PCN-149023

Product Change Notice

HSM9-C280

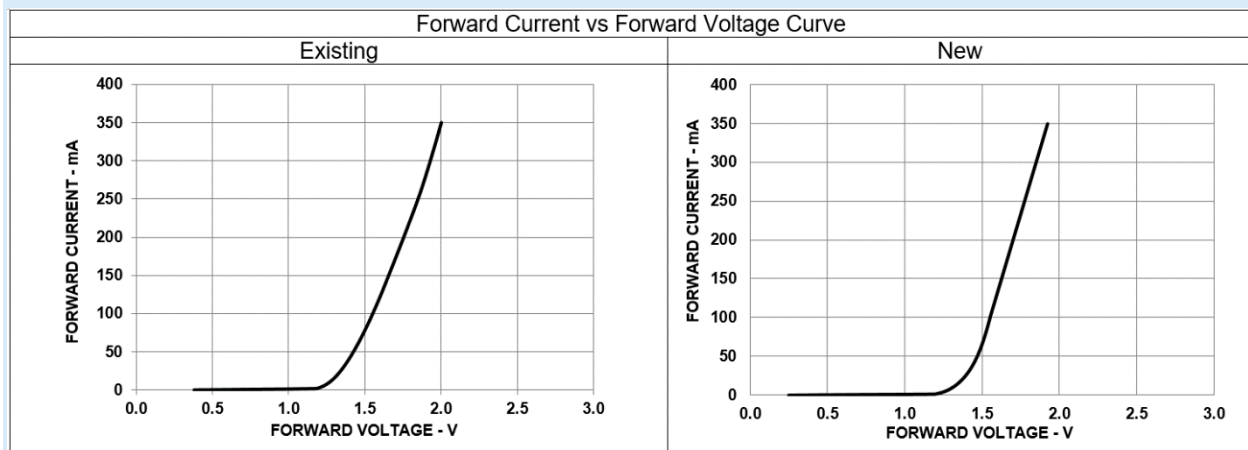
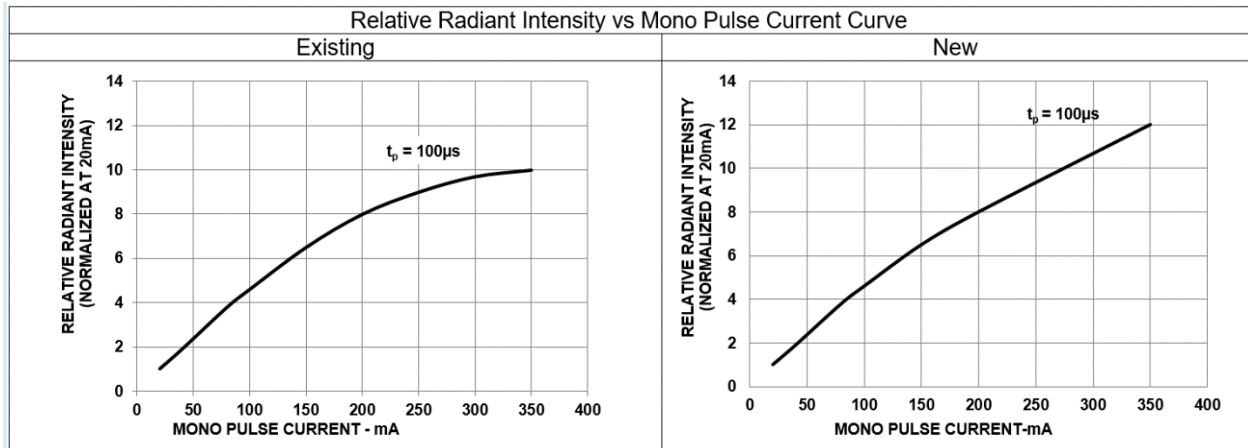
Alternate die source for affected part number listed below

The alternate die source is qualified per Broadcom's qualification process and it meets Broadcom qualification requirements.

There is no change in fit, form, quality and reliability. New forward voltage curve and relative radiant intensity curve are as per table below.
